SADDLEBROOK SUBDIVISION, UNIT FIVE

APPLICATION NUMBER 9 DATE August 7, 2008

REQUEST Subdivision

DETAIL SITE PLAN

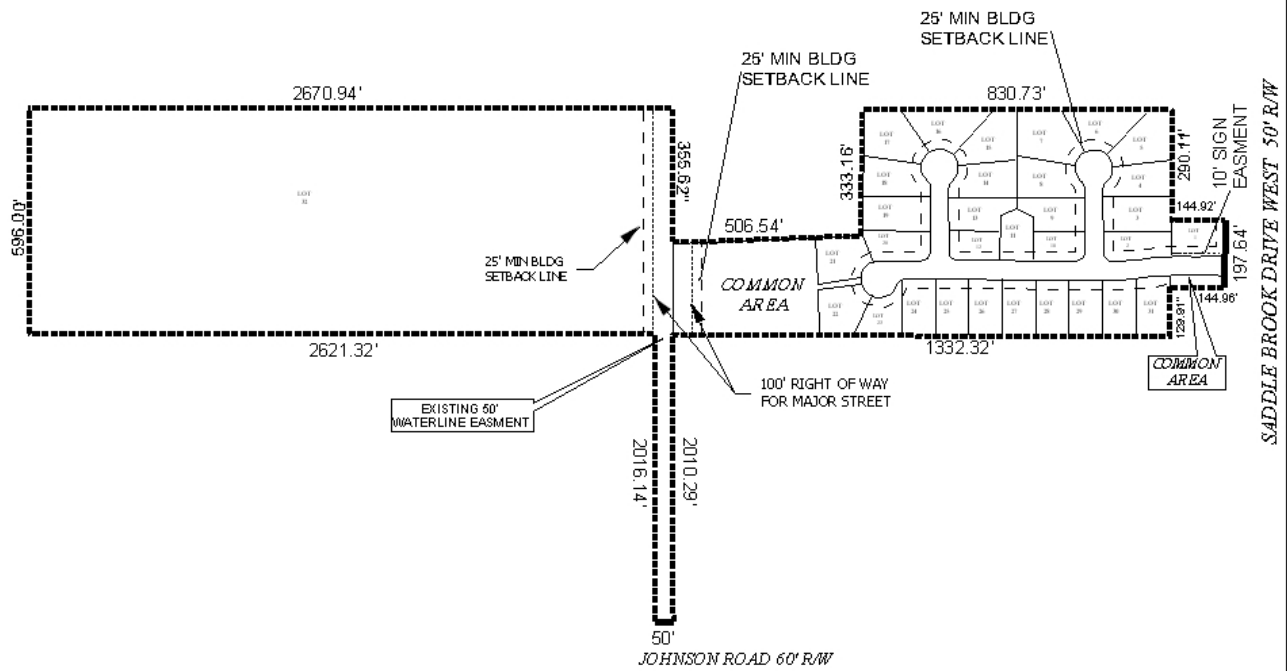
This is the first extension request since the subdivision was originally approved in 2007. Since the original approval, the Subdivision Regulations were revised in April 2008 to require a 120' cul-de-sac right-of-way diameter for closed-end streets without center medians, as per the 2003 International Fire Code requirement. Since the subdivision is proposed to have cul-de-sacs without center medians, and since road construction has not begun, the cul-de-sacs should be modified to reflect the 120' right-of-way diameter requirement.

- 1) all cul-de-sacs be modified to reflect a 120' right-of-way radius diameter as required by the 2003 International Fire Code.
